Reference no.: SDA_111053

Service information

New SW for GranBaristo Avanti, Mid and Base.

Image01

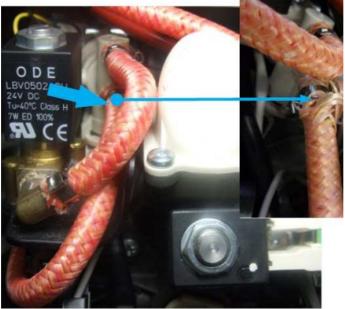
To avoid breaking of the tube, as shown in Image 01, a new SW has been released. It was decreased the time in the pre-load of the products, to reduce the excessive pressure generated in the hydraulic circuit, maintaining the amount of doses of the product unchanged.

Up to s.n. TU9015240068963 inserted the new SW Gran Baristo AVANTI SW.06.03.10 Gran Baristo MID SW.02.07.10 Gran Baristo BASE SW.01.07.10
